Work Order ID 147186

Item ID: D412-742-013 REPAIR
 Revision ID:
 Item Name: Skidtube Fits LH or RH High Gear, DART (Apical) Tri-Bag Float Compatible
 Start Date: 6/7/2016 Start Qty: 1.00
 Required Date: 6/8/2016 Req'd Qty: 1.00
 Reference: RMA RA112305-1

DART SERVICE INSTRUCTION

TO AMEND INSTALLATION INSTRUCTIONS IIN-D412-742 REV. E AND
INSTRUCTIONS FOR CONTINUED AIRWORTHINESS ICA-D412-742 REV. 4
REF FAA STC: SR01583SE
REF CANADIAN STC: SH05-37
REF EASA STC: EASA.IM.R.S.00126

FIGURE 1 - AFFECTED LOCATIONS

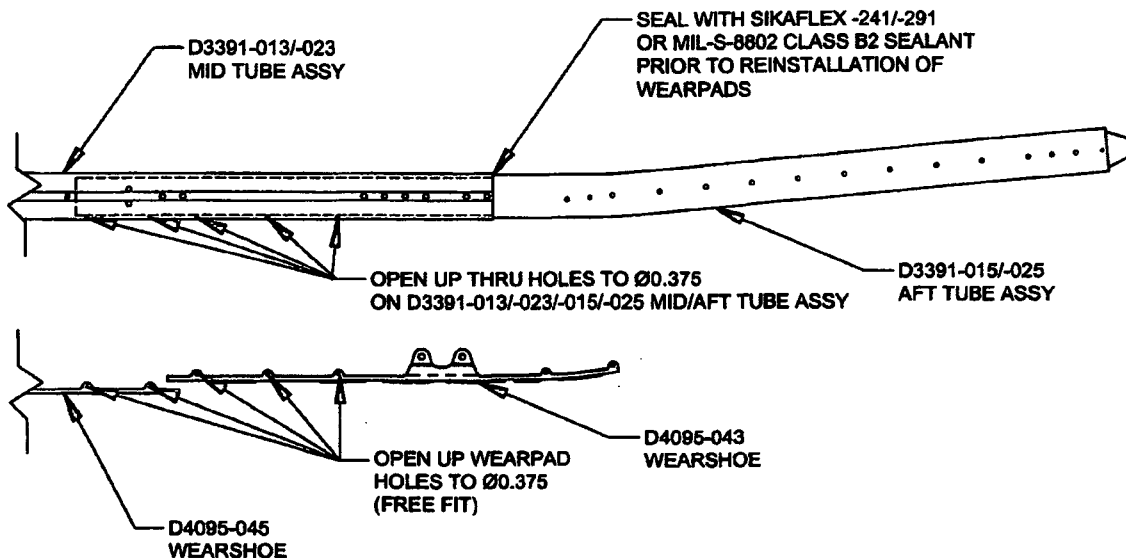
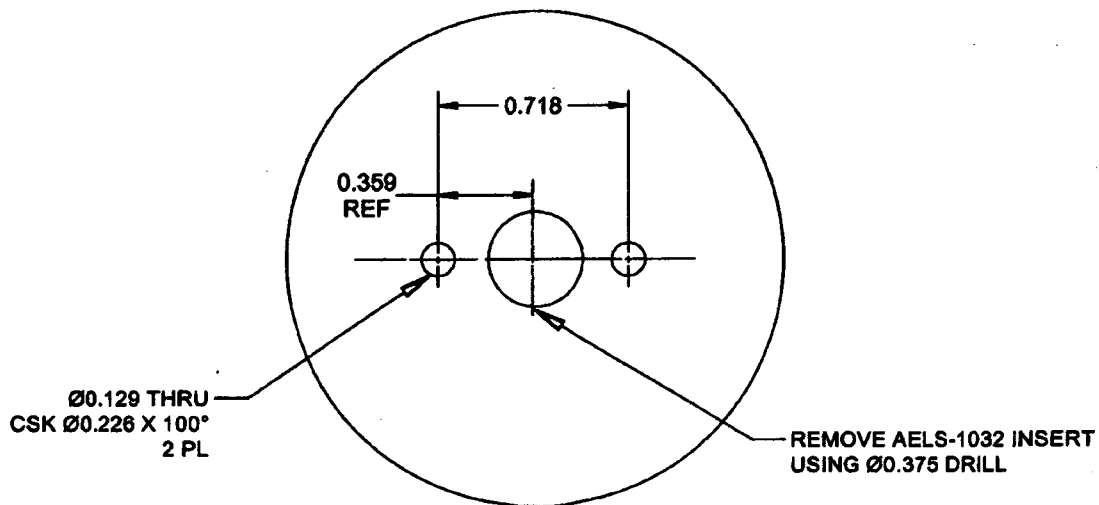
The purpose of this DART Service Instruction is to provide a repair procedure to replace spinning AELS-1032 inserts with MS21075L5 Floating Nut Plates on D412-742-011/-013 Float Skid tubes in locations where the D3391-013/-023 Mid Tube Assembly overlaps the D3391-015/-025 Aft Tube Assembly as shown in Figure 1.

- 2.1 Drill out AELS-1032 Inserts (Qty 10) located in D3391-015/-025 Aft Tube Assembly using a $\varnothing 0.375$ drill in locations shown in Figure 1. With reference to Note 2, add additional $\varnothing 0.129$ countersunk holes (Qty 2) per Detail A. skid.

- 2.2 Increase the diameter of affected thru holes in D3391-013/-023 Mid Tube Assembly with a $\varnothing 0.375$ drill bit, as shown in Figure 1.
- 2.3 Touch up affected areas with chemical film material (Alodine 1200 or 1201) per MIL-C-5541.

- 2.4 Install MS21075L5 Nut Plate (Qty 10) using MS20601AD4W4 (Qty 12) in the six (6) most forward holes and MS20601AD4W9 (Qty 8) in the four (4) aft holes. It is acceptable to replace MS20601AD4 rivets with longer or shorter rivets as required.

- 2.5 Increase diameter of affected wearpad holes on D4095-043/-045 to $\varnothing 0.375$
- 2.6 Re-install D3391-015/-025 Aft Tube Assembly in accordance with ICA-D412-742 Section 32.9. Install D4095-043/-045 Wearshoes using AN5C7A Bolts (Qty 10) and NAS1149C0532R Washers (Qty 10) in locations corresponding to this modification.
